CITY OF LA VISTA
MAYOR AND CITY COUNCIL REPORT
AUGUST 20, 2019 AGENDA

Subject:	Type:	Submitted By:
LA VISTA CITY CENTRE PRELIMINARY PLAT	◆ RESOLUTION ORDINANCE RECEIVE/FILE	CHRIS SOLBERG SENIOR PLANNER

CASE NUMBER: PSPP 19-0001

RE: Preliminary Plat – Initial Review
La Vista City Centre Theater

SHEET
C1.1

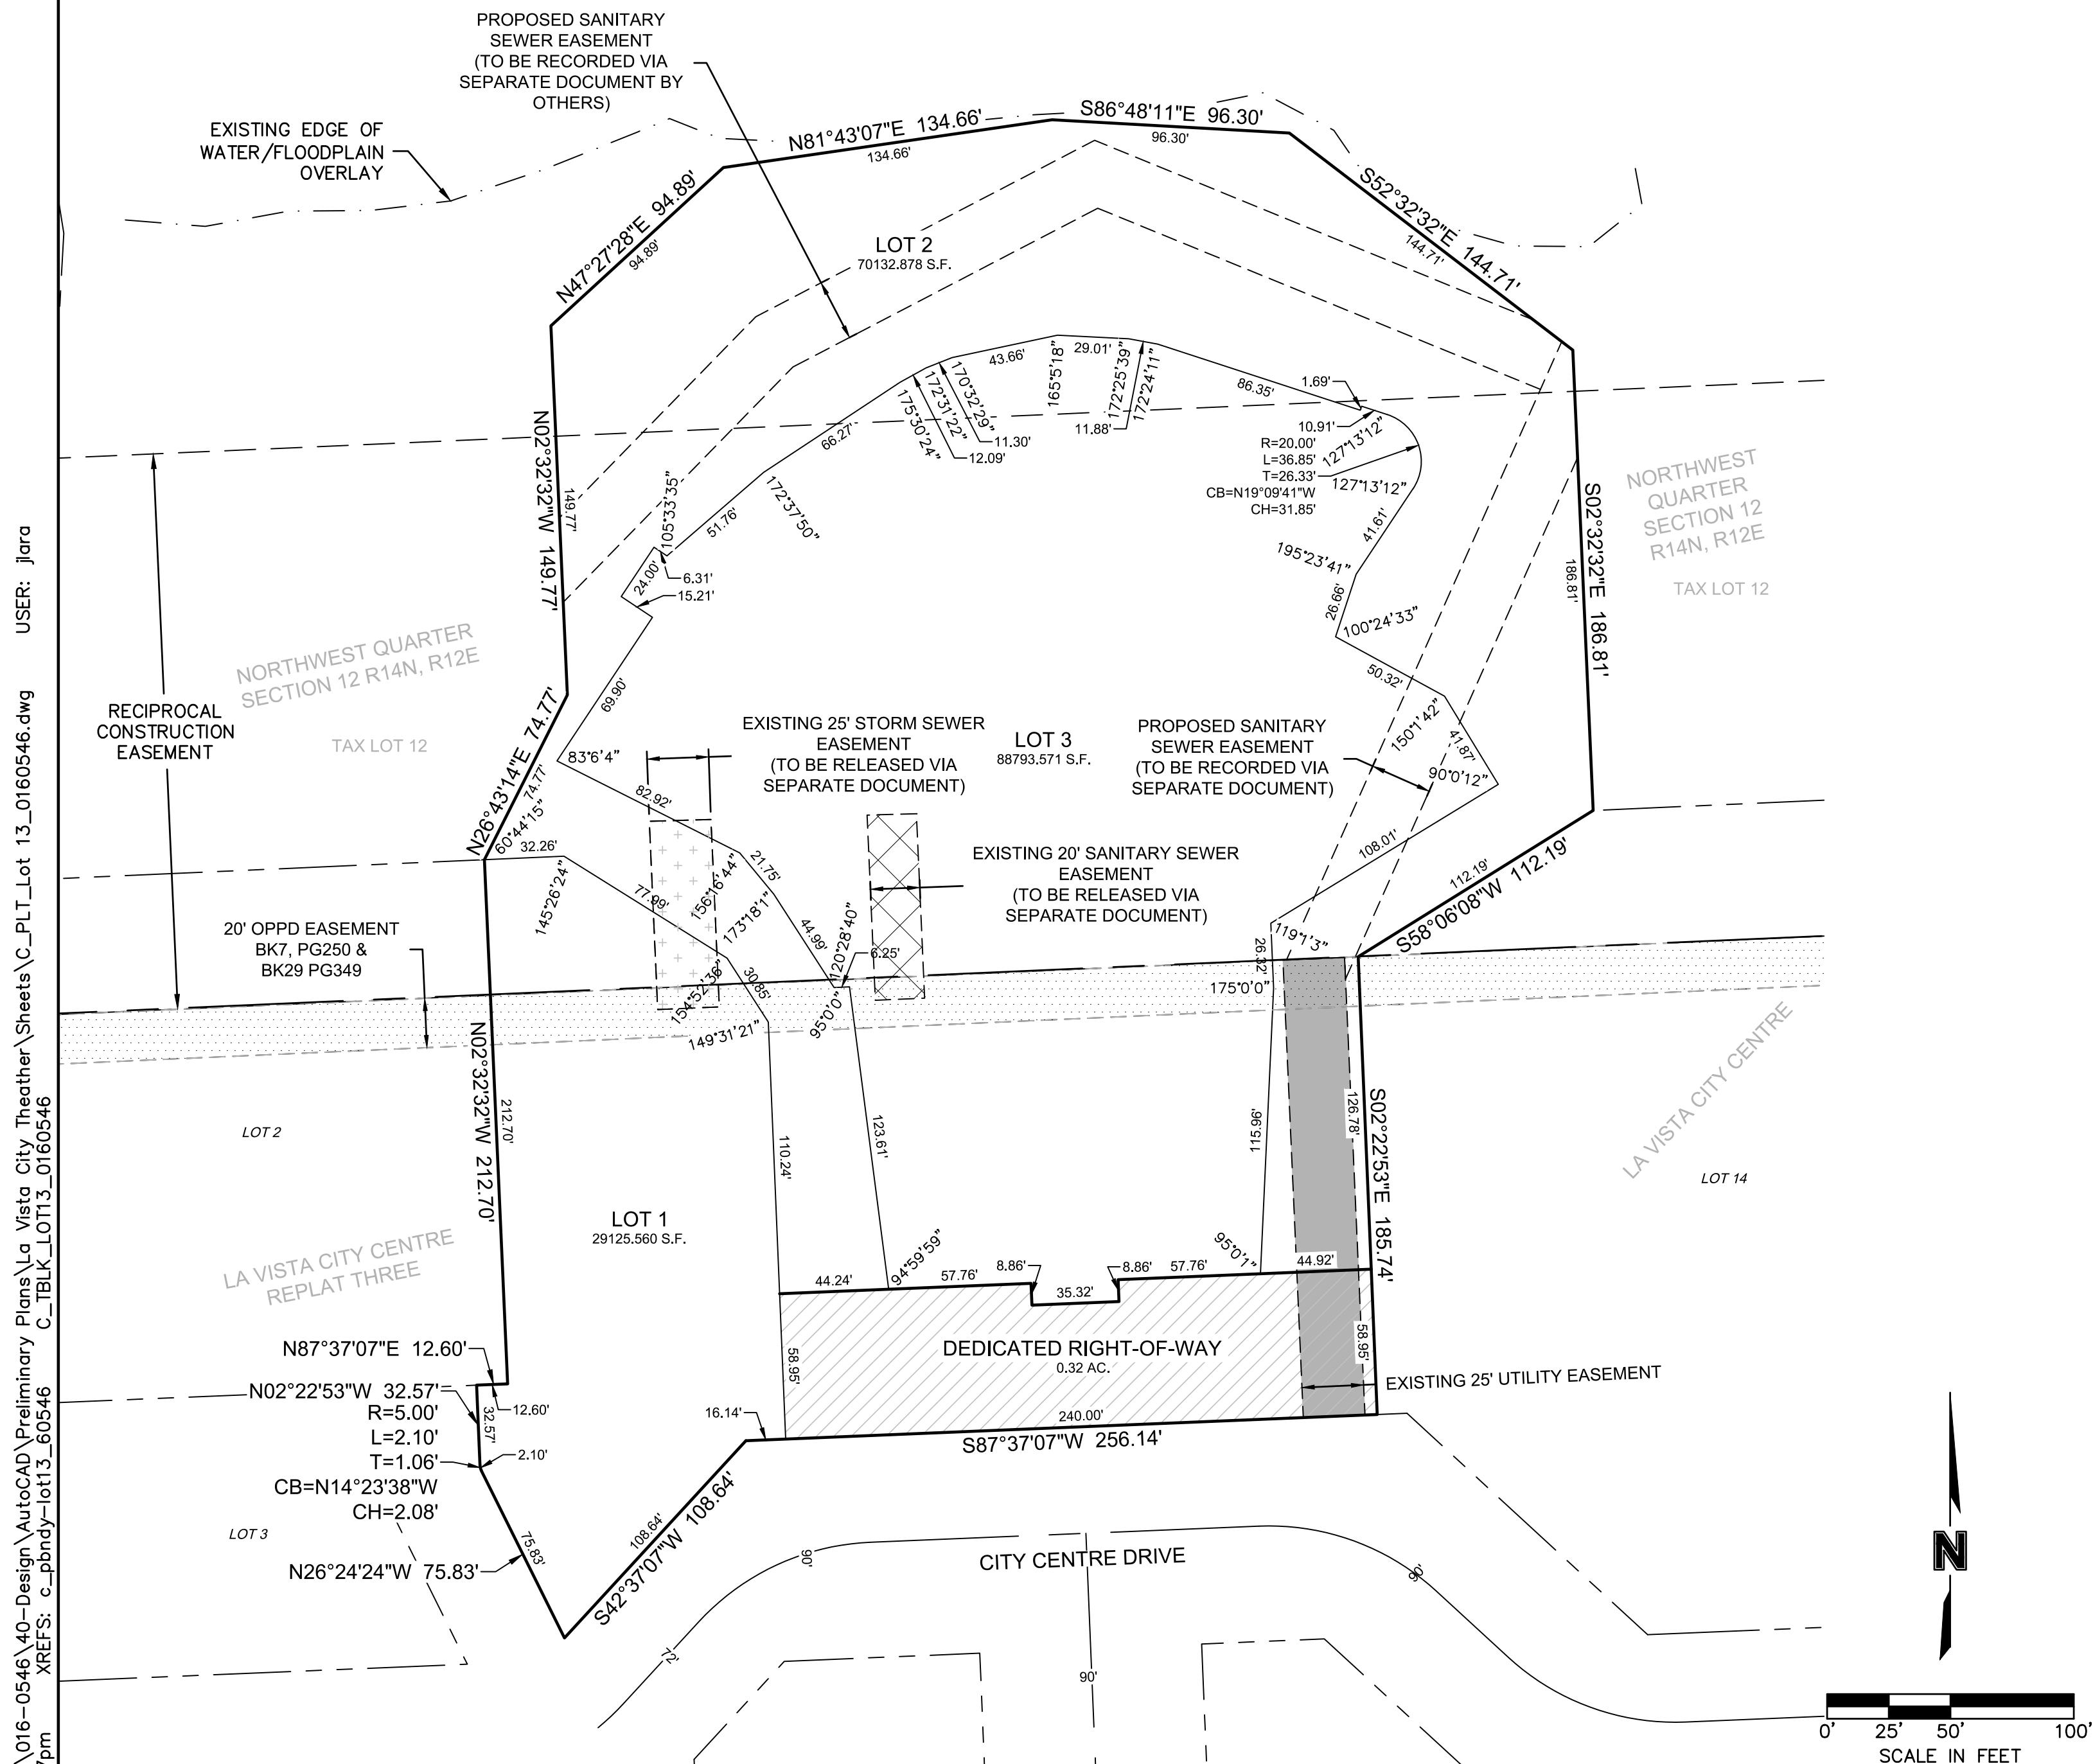
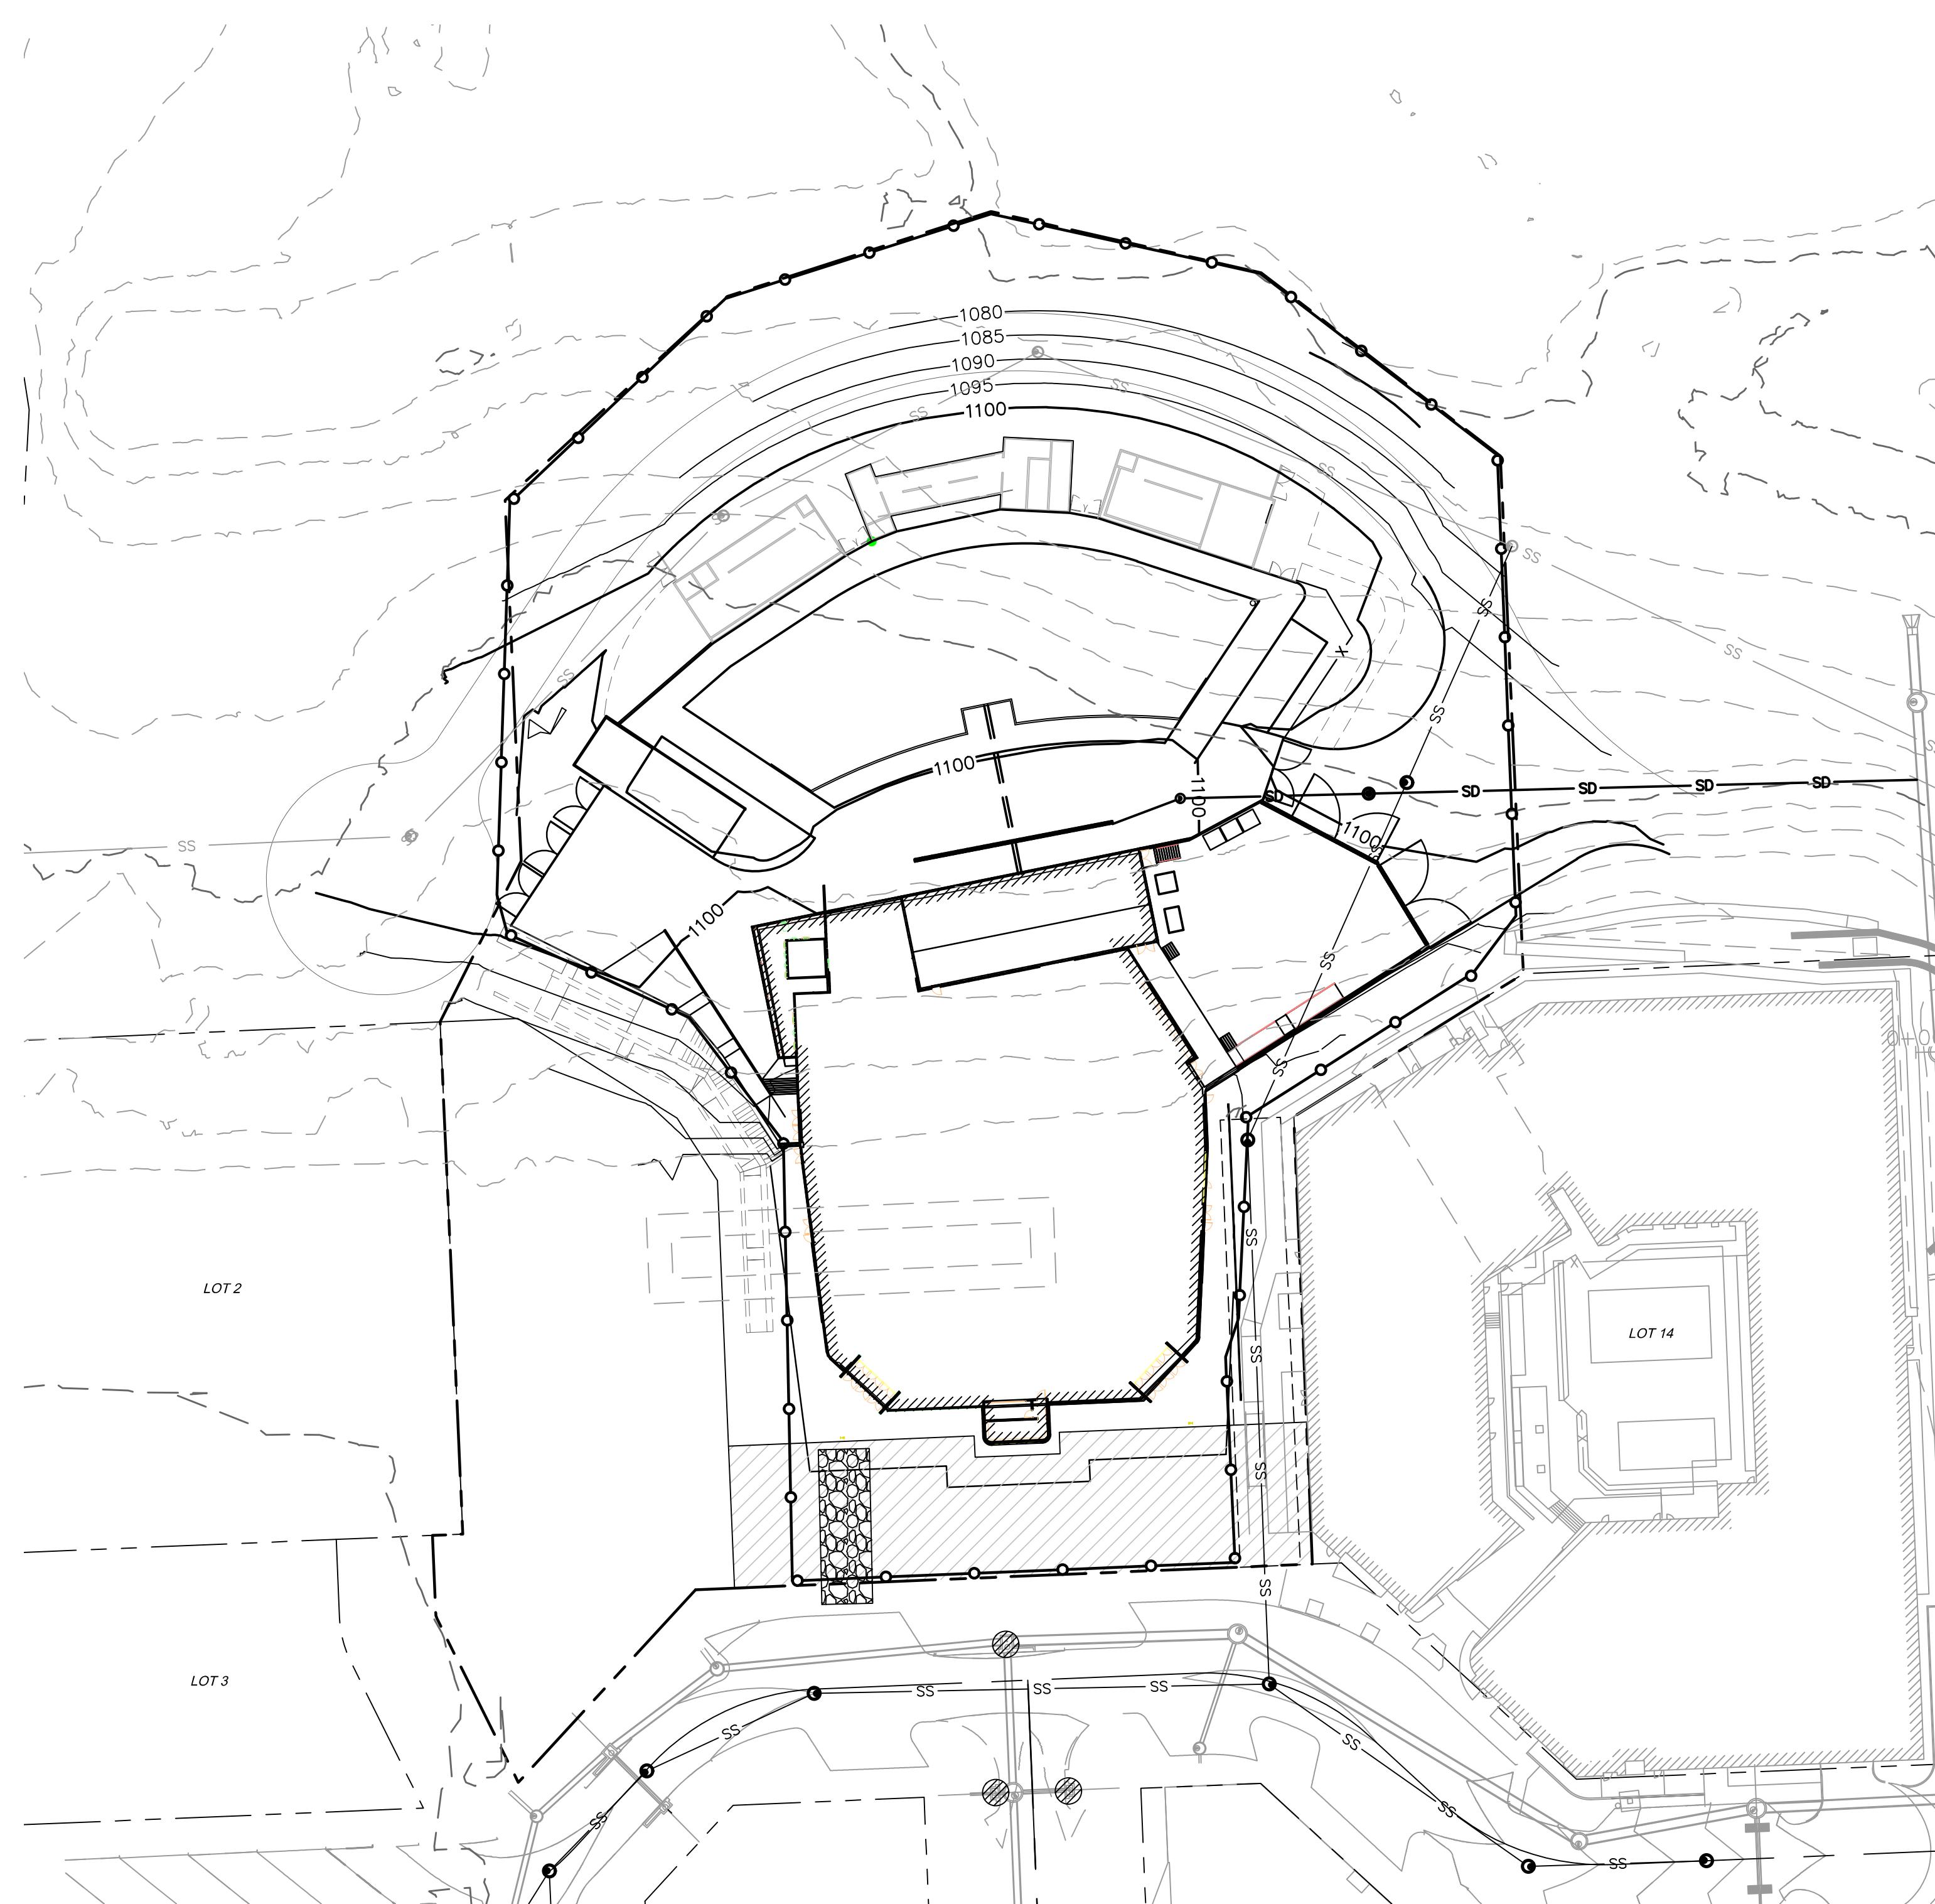
1. Article 3.03.02: Due to the nature of this preliminary plat please include proposed floor elevations on Lot 14 and on Lot 1. This should include the main floor elevation on Lot 14 and the bottom floor, stage and upper floor elevations on Lot 1.

2. Article 3.03.06: Please provide a legal description of the area being platted, including acreage of the proposed development.
3. Article 3.03.07: The location of the existing edge of normal water surface in the Civic Center Park lake needs to be shown as this affects the boundary of proposed Lot 2. The location of the relocated sanitary outfall sewer north of Lots 1 and 2 should be shown. Both of these can be based on the TD2 topographic survey of the "interface" area dated January 31, 2019. If Olsson does not already have a copy of this survey, the City will make arrangements for Olsson to receive it.

4. Article 3.03.09: The proposed lot areas should be identified in square footage and not acres since appraisals and negotiations will need the areas in square feet.

5. Article 3.03.10: An easement for the public sanitary sewer through Lots 1 and 2 to the outfall sewer needs to be shown. Any storm sewer easements (public or private) proposed over Lots 1 through 3 need to be shown. There should be notations in regards to any proposed blanket easements for ingress and egress amongst the lots and for public benefit.

6. Article 3.03.12: It appears that an existing sanitary sewer easement and an existing storm sewer easement will need to be released. Please add notations indicating the intent in regards to these easements.

7. Article 3.03.13: Please provide any established floodplain overlay lines. Per Zoning Ordinance Section 5.18, the development's proximity to the delineated Zone A Floodplain will most likely require a Floodplain Development Permit be obtained as to ensure flood hazards are analyzed as to satisfy the conditions of the aforementioned zoning ordinance.

1. Article 3.03.02: Due to the nature of this preliminary plat please include proposed floor elevations on Lot 14 and on Lot 1. This should include the main floor elevation on Lot 14 and the bottom floor, stage and upper floor elevations on Lot 1. **Response: Elevations have been provided.**

2. Article 3.03.06: Please provide a legal description of the area being platted, including acreage of the proposed development. **Response: Legal description has been provided.**

3. Article 3.03.07: The location of the existing edge of normal water surface in the Civic Center Park lake needs to be shown as this affects the boundary of proposed Lot 2. The location of the relocated sanitary outfall sewer north of Lots 1 and 2 should be shown. Both of these can be based on the TD2 topographic survey of the "interface" area dated January 31, 2019. If Olsson does not already have a copy of this survey, the City will make arrangements for Olsson to receive it. **Response: This was coordinated with TD2 and the boundary has been revised to accommodate the edge of waterway. Relocated sanitary sewer has also been provided.**

4. Article 3.03.09: The proposed lot areas should be identified in square footage and not acres since appraisals and negotiations will need the areas in square feet. **Response: This has been updated**

5. Article 3.03.10: An easement for the public sanitary sewer through Lots 1 and 2 to the outfall sewer needs to be shown. Any storm sewer easements (public or private) proposed over Lots 1 through 3 need to be shown. There should be notations in regards to any proposed blanket easements for ingress and egress amongst the lots and for public benefit. **Response: This easement has been added for the existing line through the lot.**

6. Article 3.03.12: It appears that an existing sanitary sewer easement and an existing storm sewer easement will need to be released. Please add notations indicating the intent in regards to these easements. **Response: This will be shown as released on the preliminary plat.**

7. Article 3.03.13: Please provide any established floodplain overlay lines. Per Zoning Ordinance Section 5.18, the development's proximity to the delineated Zone A Floodplain will most likely require a Floodplain Development Permit be obtained as to ensure flood hazards are analyzed as to satisfy the conditions of the aforementioned zoning ordinance. **Response: Floodplain line has been shown. If permitting is needed, this will be provided with the construction plans.**

SHEET
C3.1

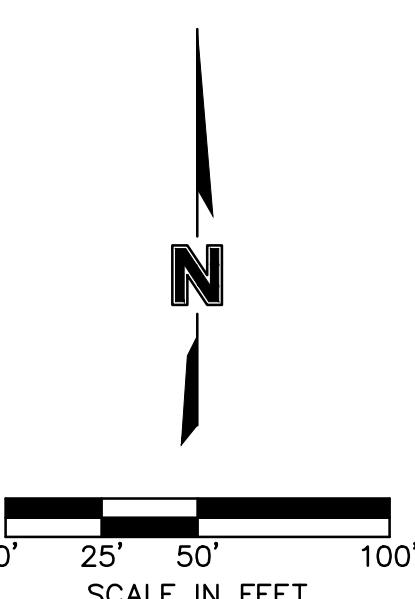
9. Article 3.03.16: On Sheet C3.1 some notations or illustrations are needed to address this requirement. The overall disturbed area will exceed five acres and add notations that sediment traps/basins, silt fences, and inlet filters will be utilized for sediment control at a minimum. Dependent on which entity undertakes the site preparation grading for these lots will identify which erosion control permit needs to be modified in Permix to include this area.

11. Article 3.03.20:
 - a. Per Item 2 above, show the sanitary outfall sewer.
 - b. The storm drainage plan (Sheet C3.1) needs to include conceptual information for proposed water quality treatment. The 2-year peak runoff increase can be addressed in the storm water detention facility in Civic Center Park.

- c. Information concerning a PCSMP plan needs to be provided on Sheet C3.1. This would include reference to the current plan for PCSMP No. 20170324-3736P and particularly Note 2 on Exhibit "B". Notations as to how runoff from the proposed truck dock and bus parking aprons will be treated are needed at a minimum. These locations have the most potential for pollutants that could affect the lake.

9. Article 3.03.16: On Sheet C3.1 some notations or illustrations are needed to address this requirement. The overall disturbed area will exceed five acres and add notations that sediment traps/basins, silt fences, and inlet filters will be utilized for sediment control at a minimum. Dependent on which entity undertakes the site preparation grading for these lots will identify which erosion control permit needs to be modified in Permix to include this area. **Response: Note has been added.**

11. Article 3.03.20:
 - a. Per Item 2 above, show the sanitary outfall sewer. **Response: Provided.**
 - b. The storm drainage plan (Sheet C3.1) needs to include conceptual information for proposed water quality treatment. The 2-year peak runoff increase can be addressed in the storm water detention facility in Civic Center Park. **Response: Storm quality structure has been provided.**

- c. Information concerning a PCSMP plan needs to be provided on Sheet C3.1. This would include reference to the current plan for PCSMP No. 20170324- 3736P and particularly Note 2 on Exhibit "B". Notations as to how runoff from the proposed truck dock and bus parking aprons will be treated are needed at a minimum. These locations have the most potential for pollutants that could affect the lake. **Response: PCSMP information has been added to sheet C3.1 and PCSMP # has been added. A trench drain has been added along the front of the truck dock and will tie in before the vortex system.**
